**Report of the informal correspondence group on burning
rate: Amendments to subsection 51.4 of the Manual of Tests
and Criteria**

**Transmitted by the expert from China on behalf of the informal
correspondence group**

This document contains the text of section 51 of the Manual of Tests and Criteria with the amendments proposed by the informal correspondence group listed in document ST/SG/AC.10/C.3/2024/41 – ST/SG/AC.10/C.3/2024/7.

Figure 51.4.1: Measurement of radiation as a function of time

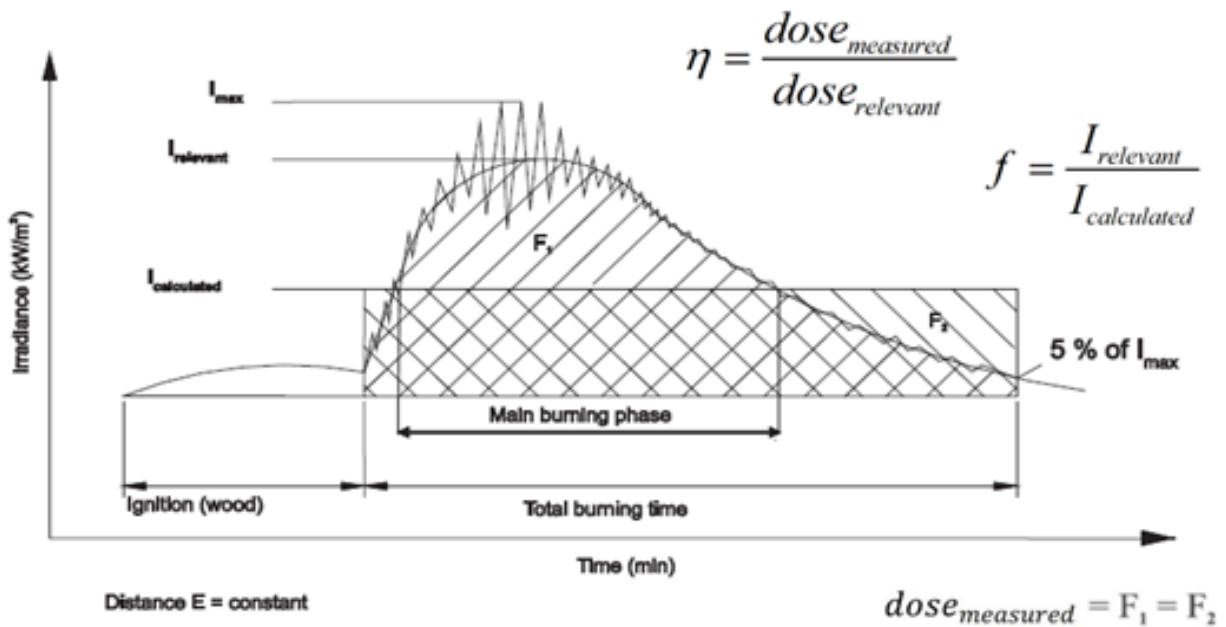
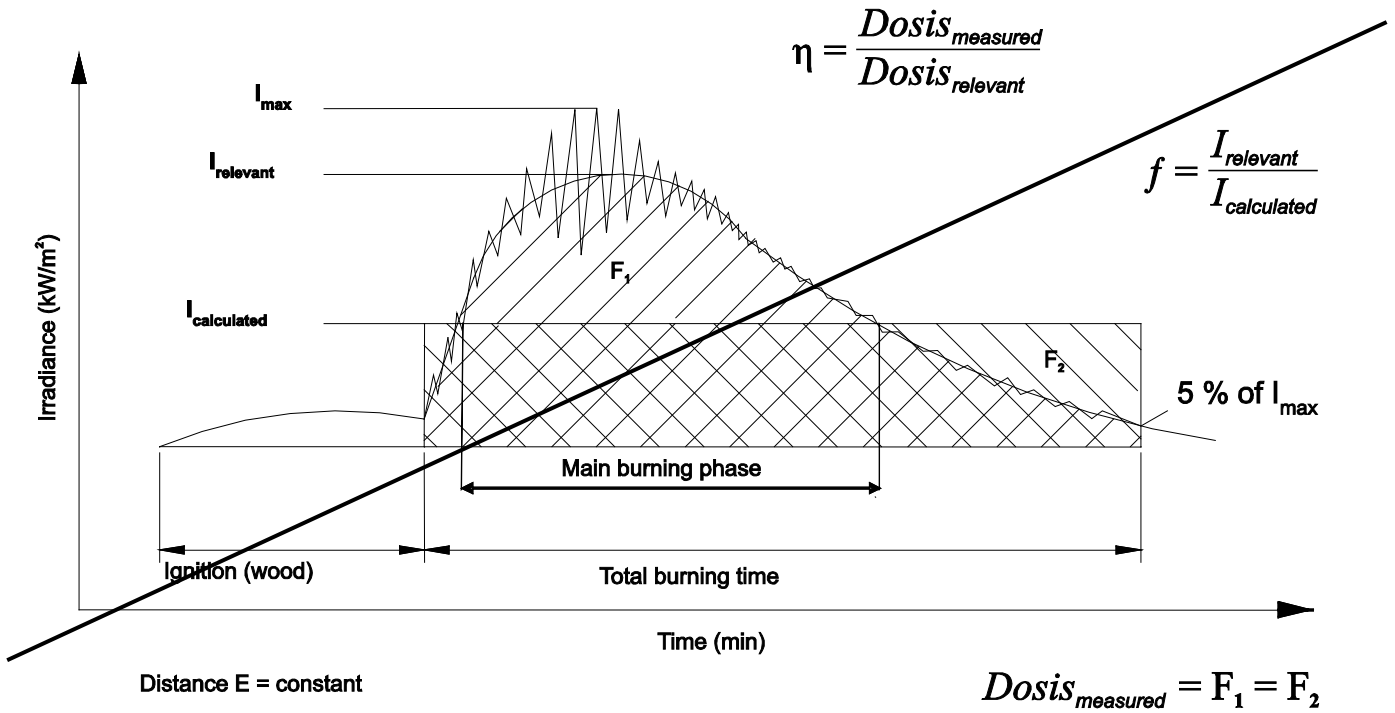
- (a) The starting point of the fire is defined as the moment at which the substance or mixture reacts detectably. The end **point** of the fire is characterized by a decrease in **irradiance radiation level** I (as caused by the fire) to less than 5 % of the maximum **level irradiance** (I_{max}). **The maximum irradiance (I_{max}) is an average of the irradiance measured over a period of at least 30s during the period of peak thermal radiation. The total burning time t is the time span between the starting point and the end point of the fire** (see figure 51.4.1);
